# Parkscene Bangladesh Ltd Parkstar (Parkzone)

Mouza Kunia . JL No,. 406, Gazipur Sadar. Gazipur

(23.934767N, 90.387349E)  
20th April 2014

# Observations

# Heavy Loading on Slabs

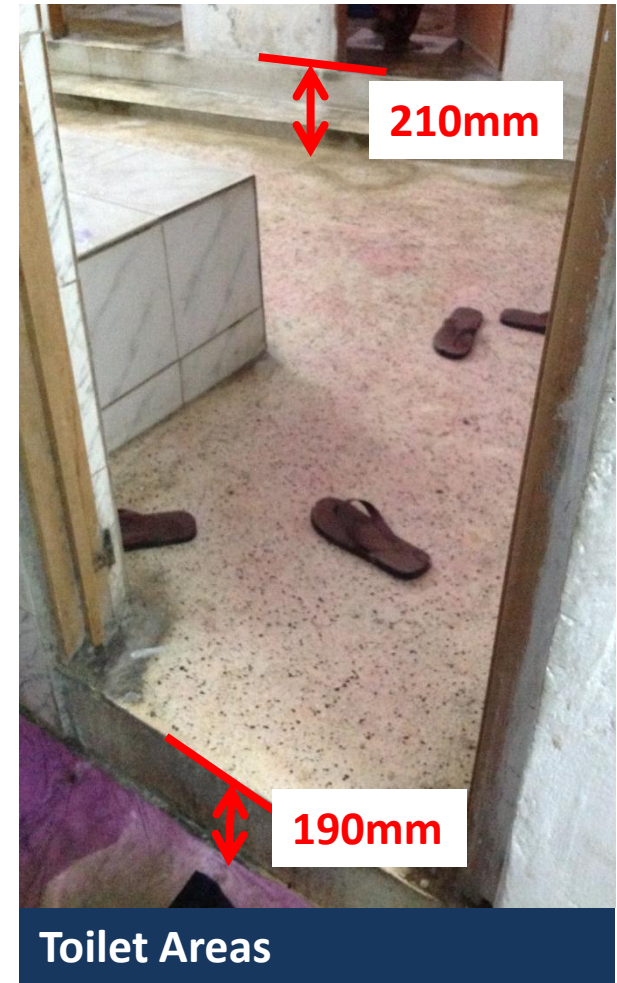
Heavy loading was observed in several locations on floor and roof slabs:

- Water tanks on the roof slabs above stairs
- Toilet areas
- Storage areas
- Masonry partition walls at 2<sup>nd</sup> Floor

## Storage areas

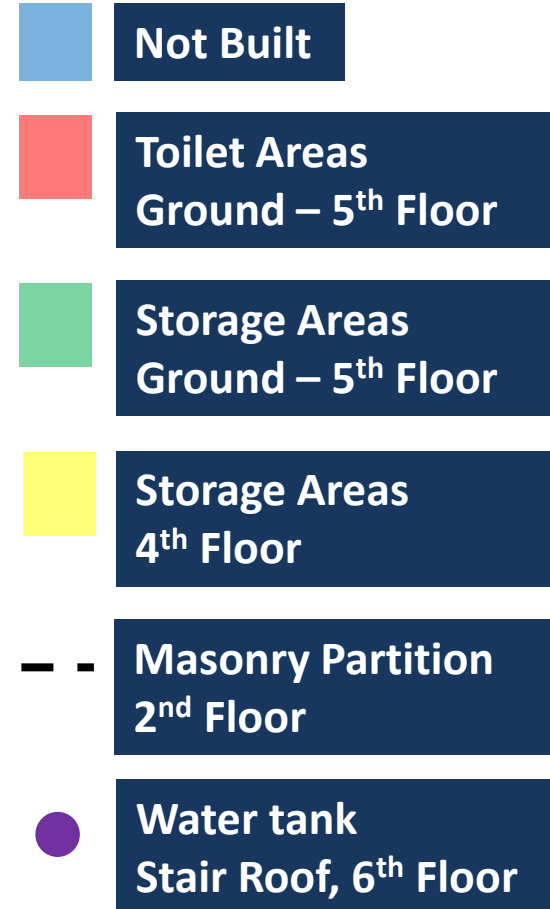
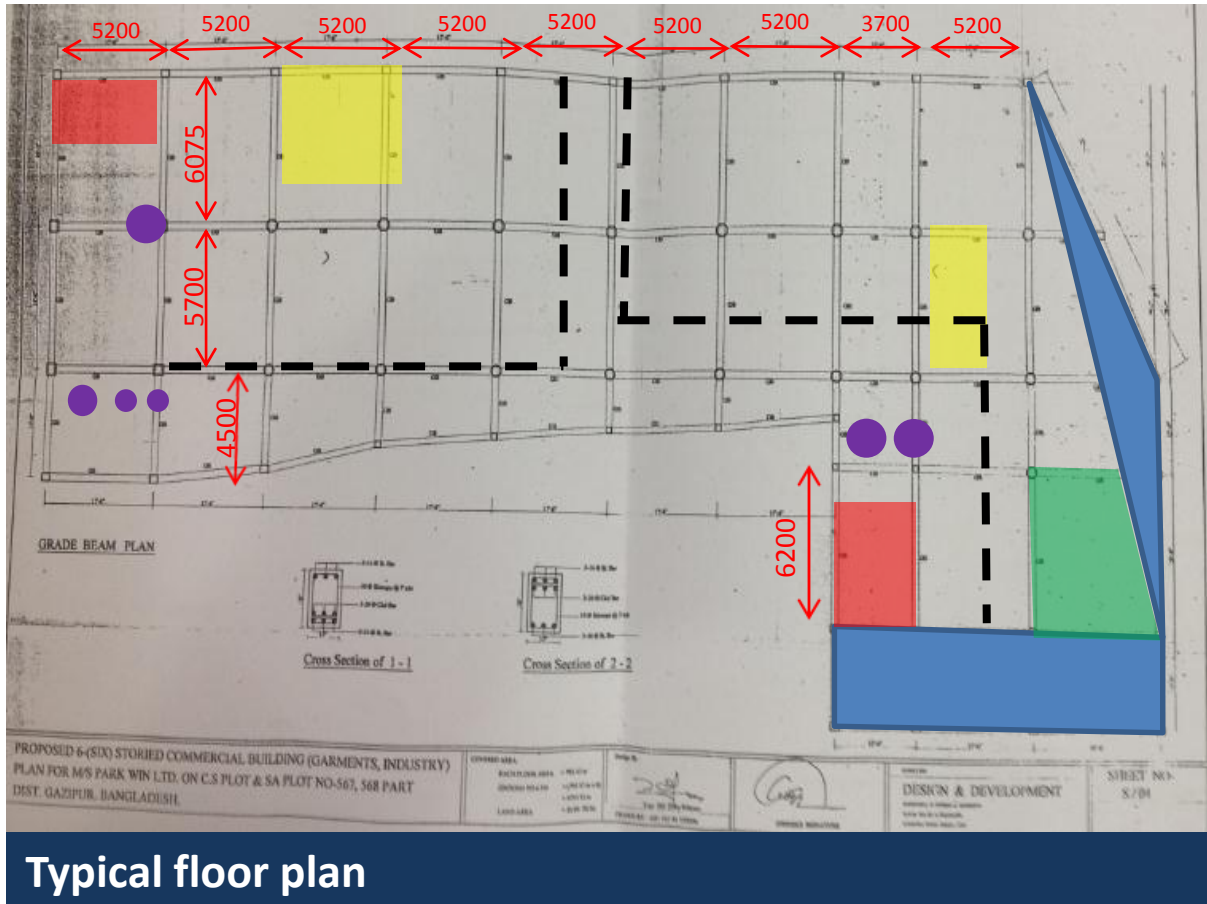
$5 \text{ kN/m}^2$   
estimated live load

$2 \text{ kN/m}$  estimated  
superimposed dead load

## Masonry partition walls

# Non-Permitted Additional Storey

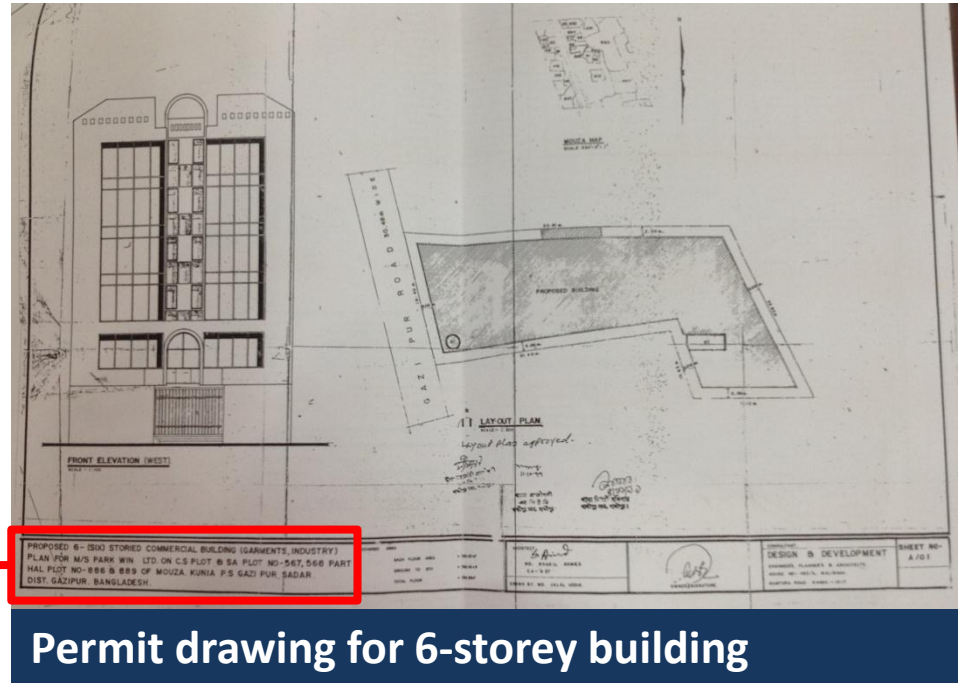
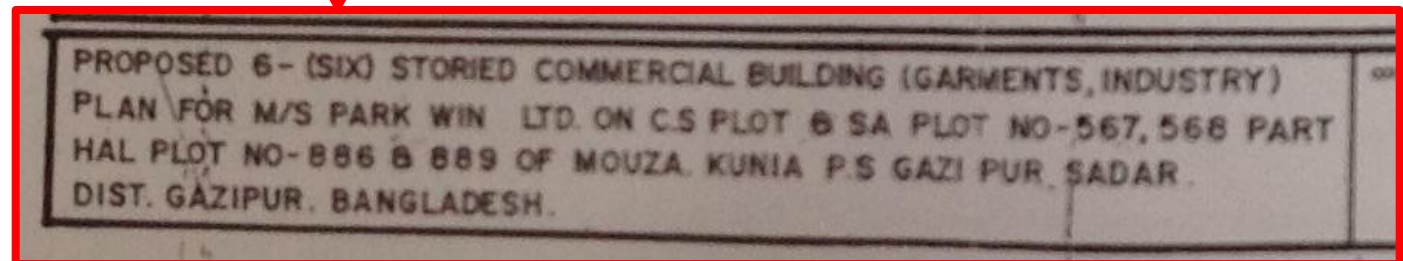
A shed roof has been erected over the former R.C. roof to create a usable floor space at the roof level (6<sup>th</sup> Floor), so the building now has seven (7) occupied storeys. The Building Permit is for a 6-storey building. The 6<sup>th</sup> Floor is currently being used for sewing and prayer, and it has also been used for dining.

Permit drawing for 6-storey building

| Item No. | Observation                                                               | Recommended Action Plan                                                                                                                                                     | Recommended Timeline |
|----------|---------------------------------------------------------------------------|-----------------------------------------------------------------------------------------------------------------------------------------------------------------------------|----------------------|
| 13       | Non – permitted additional storey and associated non engineered structure | As-built documents to be completed as part of DEA                                                                                                                           | 6-weeks              |
| 14       | Non – permitted additional storey and associated non engineered structure | Engineer inspect and design and detail remedial works                                                                                                                       | 6-weeks              |
| 15       | Non – permitted additional storey and associated non engineered structure | Carry out remedial works as required                                                                                                                                        | 6-months             |

# Crack in Wall Panel between Roof Trusses

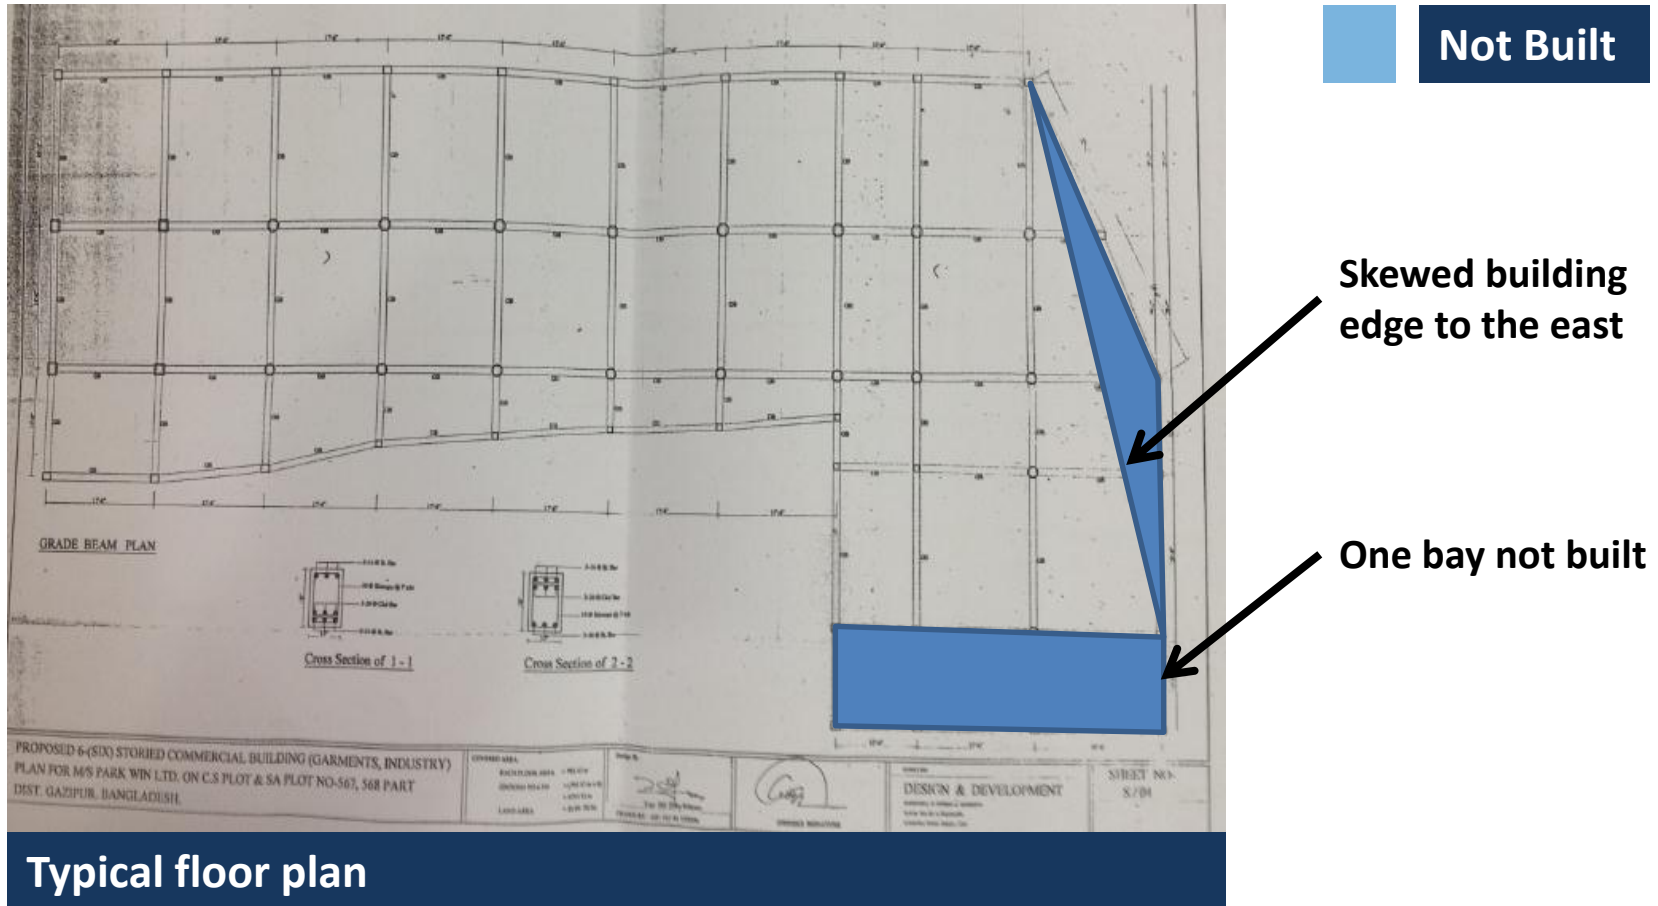
A crack was observed in the masonry wall panel below a window between the roof trusses at the 6<sup>th</sup> floor.  
This was an isolated area

Crack in wall panel

# Observed Aggregate

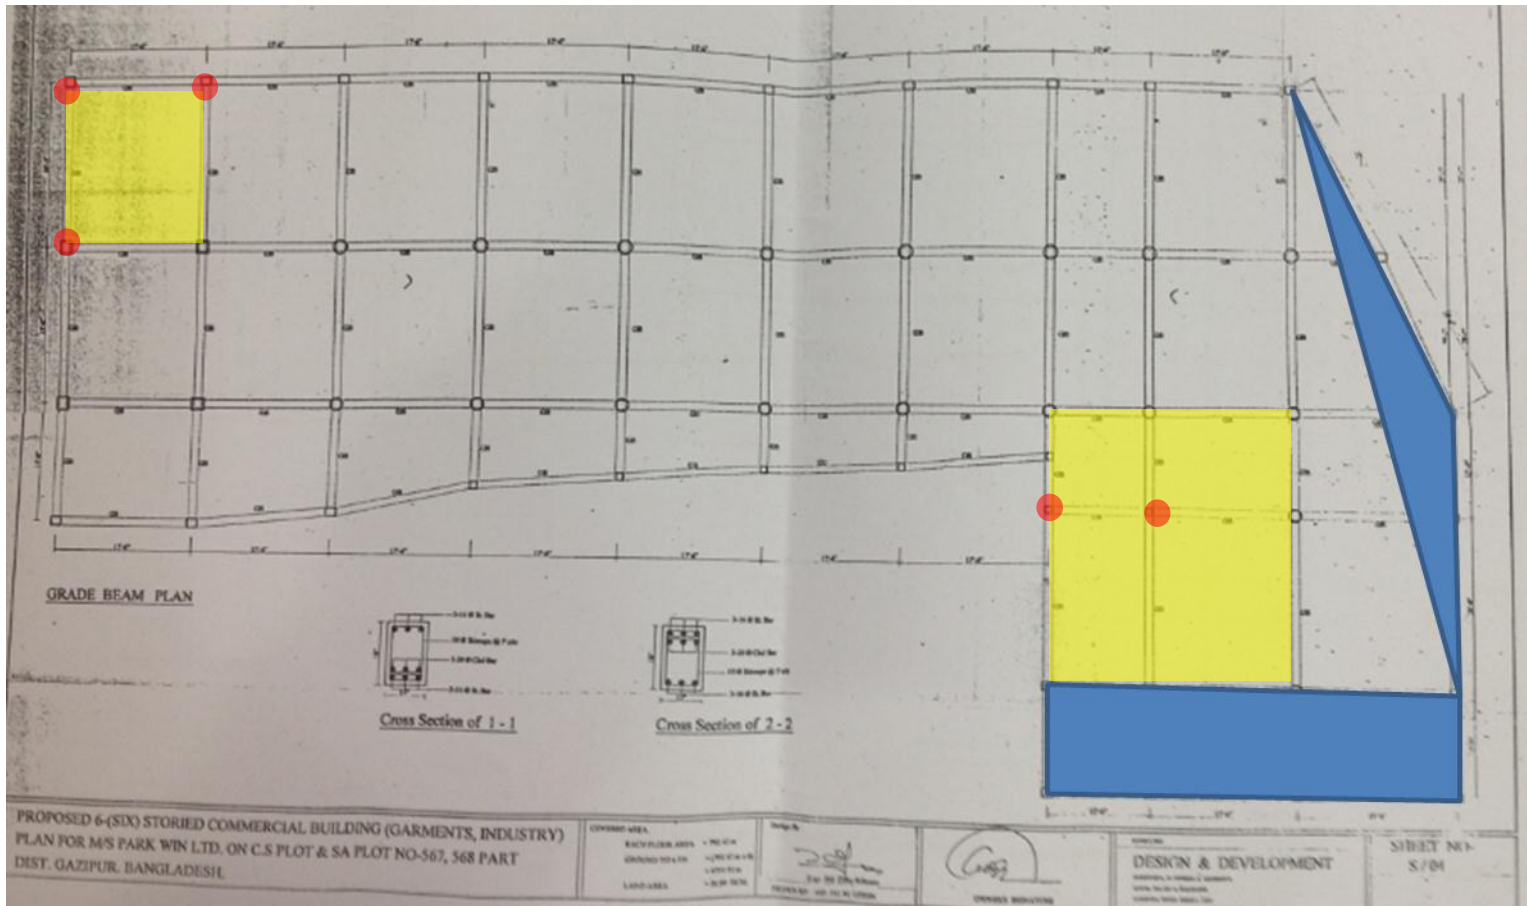
**Brick aggregate was observed in the 6<sup>th</sup> Floor slab and in columns at the Ground Floor.**

**Brick aggregate in slab**

**Brick aggregate in column**
